## ZONING AND PLATTING COMMISSION SITE PLAN COMPATIBILITY WAIVER REVIEW SHEET

**CASE NUMBER:** SP-2017-0456C

**PROJECT NAME:** Harrisglenn Corner

**WAIVER REQUEST:**

HARRISGLENN CORNER  
13414 HARRISGLENN DRIVE, AUSTIN  
SITE PLAN

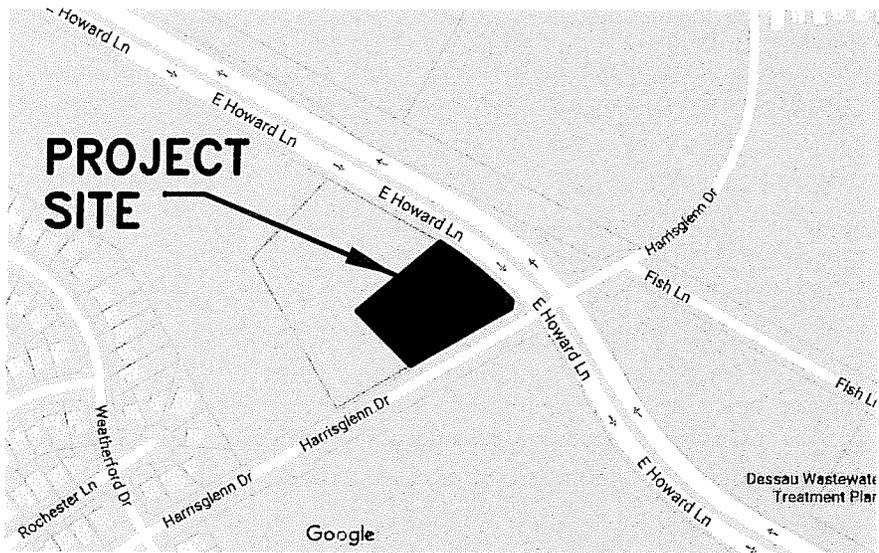
The applicant requests a waiver under 25-2-1081(A) to reduce the compatibility setback from 25 feet to 5 feet.

Staff recommends approval of the compatibility waiver request. The site plan will comply with all other requirements of the Land Development Code prior to its release.

The applicant proposes a 6,075 SF gas station and convenience store on an undeveloped 1.49-acre site. Adjacent to the north and west are drainage and water quality lots for a single-family neighborhood that is platted but not constructed.
